**NEC**

## i766/i766Ex Software Release 01.19.0003

FCO 2019.017

**System** : Business Mobility DECT  
**Date** : 25 February 2019  
**Category** : General Release  
**Product Identity** : i766/i766Ex Software Release v01.19B0003

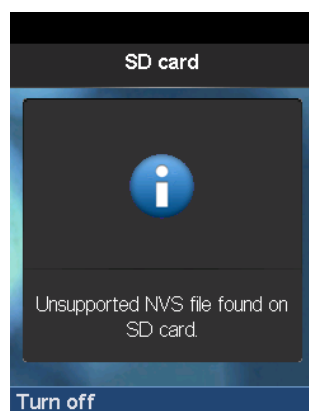
- Warning on x66 handset when a SD card from a x77 handset is inserted (see example picture)
